MINISTRY OF TRANSPORT OF THE RUSSIAN FEDERATION FEDERAL AIR TRANSPORT AGENCY AIRWORTHINESS DIRECTIVE

No. 2023-AHCAT-CK-04

Applicability – ANSAT helicopters (ANSAT-GC model)

TECHNICAL DECISION No. 2/144-2023-KB3

Fig. 1 Fuel tanks installation in the ANSAT helicopter (model ANSAT-GC)

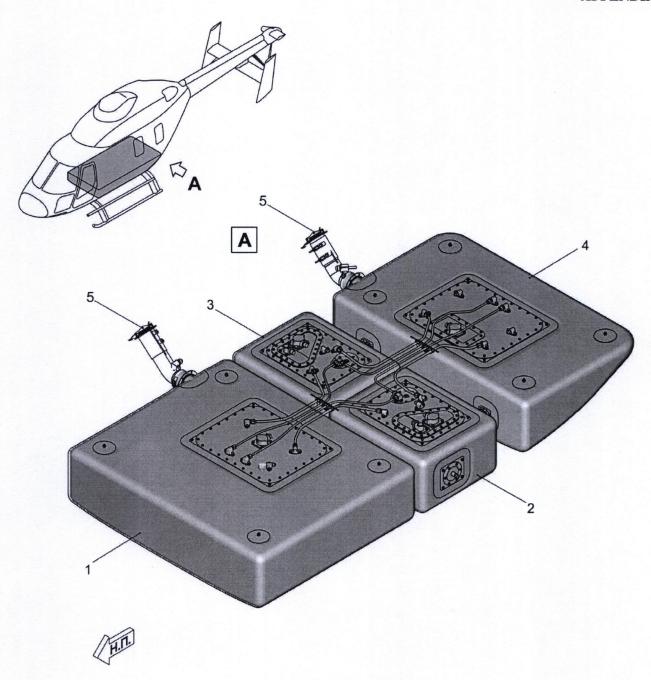
- 2.3 Inspect rubber gaskets installed on the fuel tanks (see Appendix 1) for presence of delamination, crumbling, cracks.
- 2.4 Inspect the internal cavities of all fuel tanks for presence of rubber particles (products of destruction of rubber gaskets).

- 2.6 Replace rubber gaskets (see pos. 7-16 in Appendix 1) with new ones.
- 2.7 Install the fuel system components removed according to the p. 2.2 in accordance with the task card 028.10.00d. Install the angle-pieces of the pipelines attachment to the fuel tank plates in place by screwing the mounting screws with a torque M=4.4+0.5Nm (0.45+0.05 kgf·m), lock the screws in accordance with p. 4.5 of OCT 1 39502-77 standard.

Fig. 6 Cover assembly

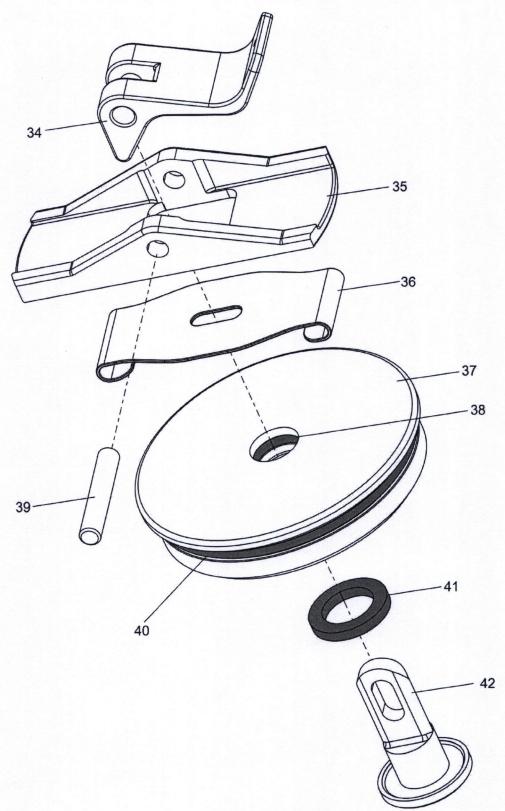
- 2.8 Replace the washer 334.6110.668 (see pos. 41 in Appendix 1) from cover assembly 334.6110.660 (see pos. 5 in Appendix 1) in accordance with temporary task card 028.10.00h (Appendix 2).

Corrective actions	re 201). Replace the ring te BK-9	
Temporary task card 028.10.00h Procedure: Replacement of washer 334.6110.668 in cover assembly	Operations and technical requirements	1 Remove the axle (pos. 4 figure 201) by knocking out and disassemble the cover assembly. 2 Perform visual inspection of rubber rings (pos. 8, 9 figure 201) without their removal from cover (pos. 5 figure 201). 3 Replace rubber washer (pos. 7 figure 201) with a new one. 4 Assemble the cover assembly, the axle (pos. 4 figure 201) removed according to p. 1, install using glue BK-9 IIM1.2A.526-99. Ensure free and jam-free rotation of the lever relative to the axle.
